RE: ASHTABULA COUNTY
RED BROOK BASIN
CITY OF ASHTABULA
ASHTABULA ELEMENTARY SCHOOL CAMPUS

NOTICE OF DEFICIENCY

Figure 3. Heavy amounts of offsite tracking were observed along Wade Avenue.

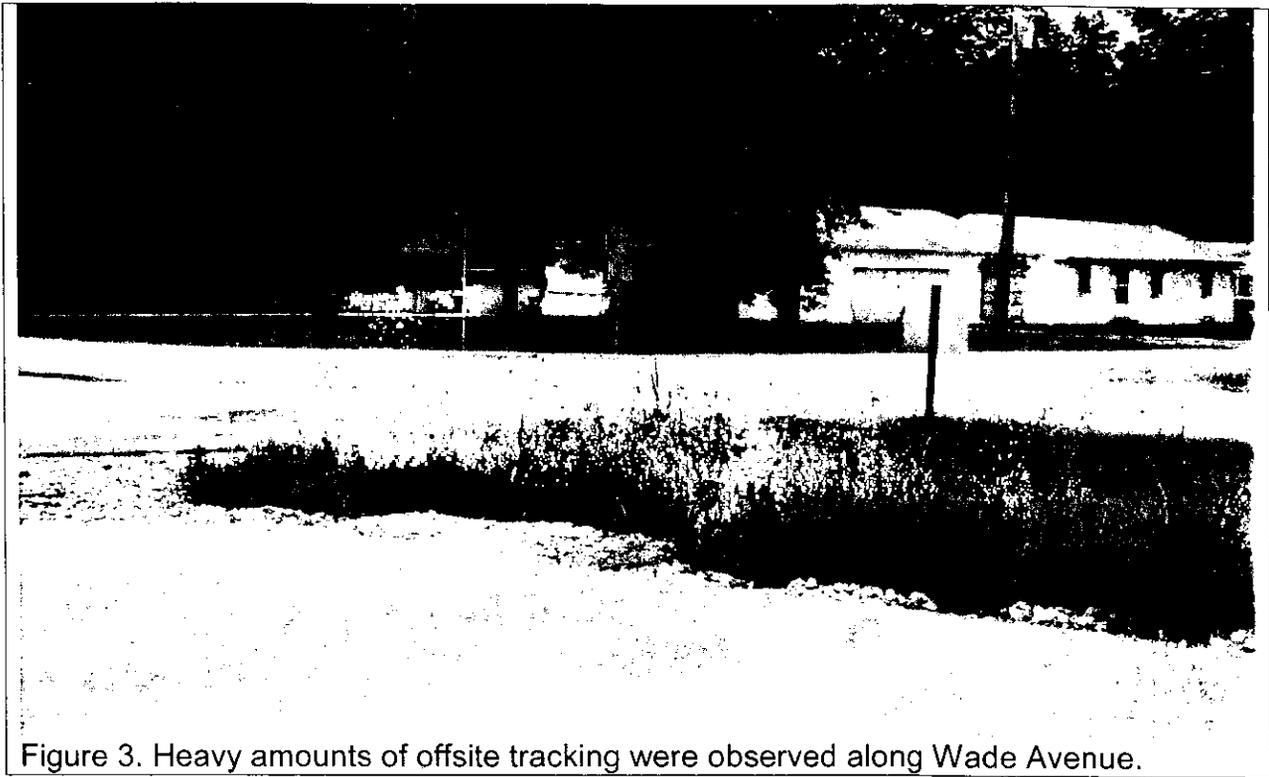
- Heavy amounts of offsite tracking were observed (Figure 3). Mud spilled, dropped, washed or tracked onto public roads shall be removed immediately by scraping or sweeping.
